BURLINGTON RESOURCES

Ute Mountain Ute #51

1500'FSL, 2270'FWL, Section 14, T-32-N, R-14-W, San Juan County, New Mexico

Burlington Resources is applying for administrative approval of a non-standard location for the above location in both the Hermosa and Paradox formations. This application for the referenced location is due to terrain and at the request of the Ute Mountain Ute Tribe.

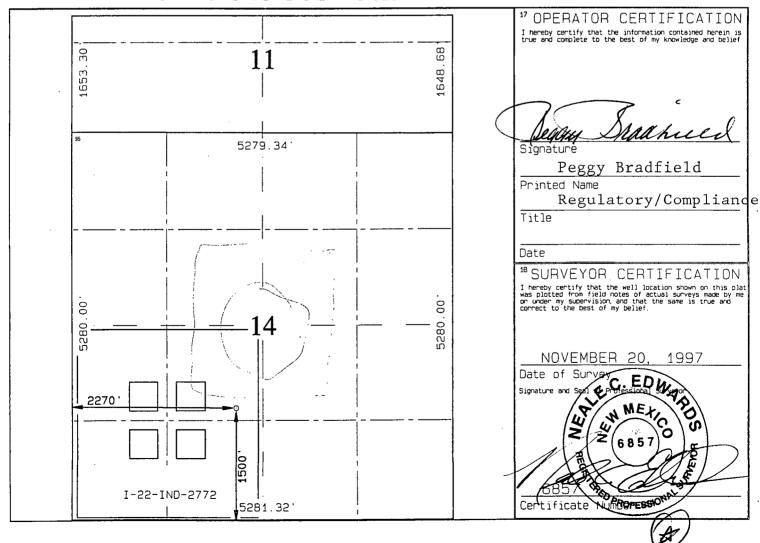
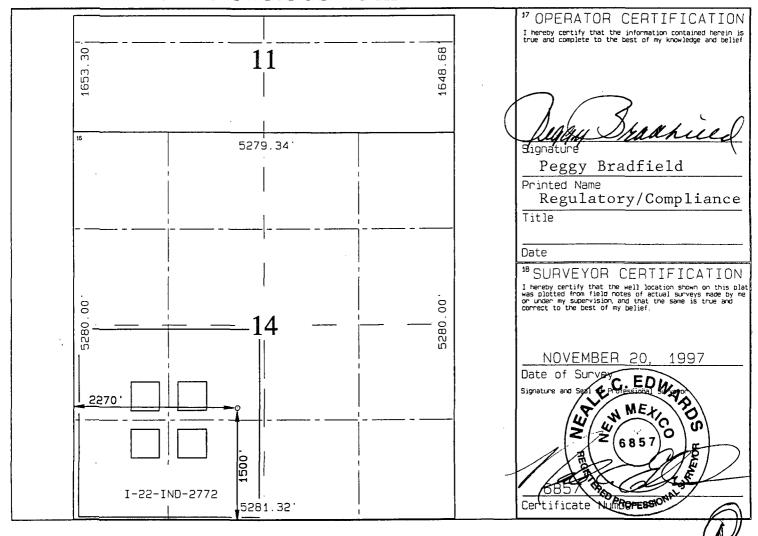
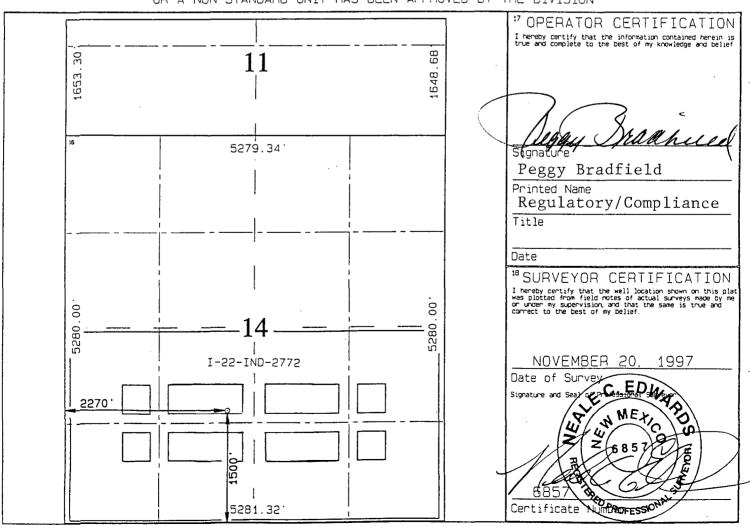
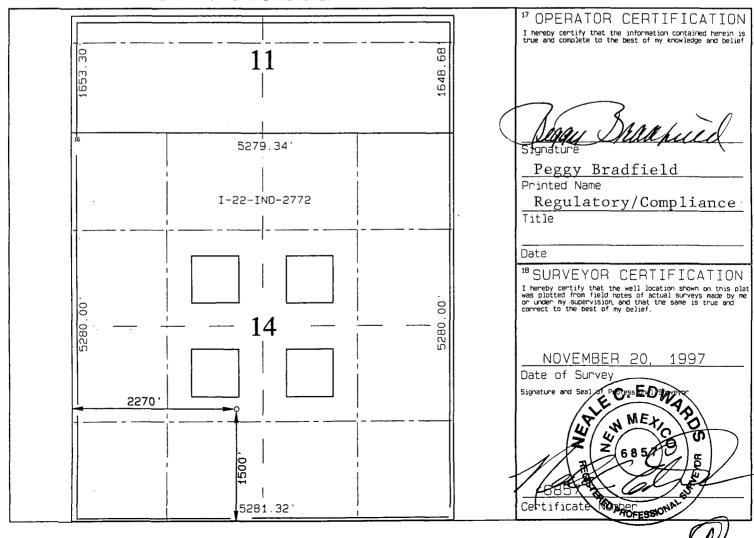
Your cover letter requested a non-standard location for the wildcat Hermosa formation (160-acre) and Barker Dome-Paradox Pool (640-acre), while the federal APD and NMOCD Form C-102 both indicate that the Barker Dome-Ismay Pool (160-acre spacing) was to be included. Further, Order No. R-46-B provided the establishment of a 842-acre unit comprising all of Sections 11 and 14-T32N-R14W and allowed the drilling of two wells within this interval.

So that I may understand exactly what Burlington is requesting in this matter please provide me separate C-102 Forms for each and every interval to be completed in this well (rather the well is standard for that zone or not) and on each plat show the orthodox window allowed for that interval. For the Barker Dome-Paradox Pool please show any existing wells within the 842-acre non-standard unit.

In response to our telephone conversation and your e-mail message, I have enclosed a C102 well location plat for each individual formation for the referenced well. The C102 plat shows the orthodox window for that particular formation and the dedicated acreage.
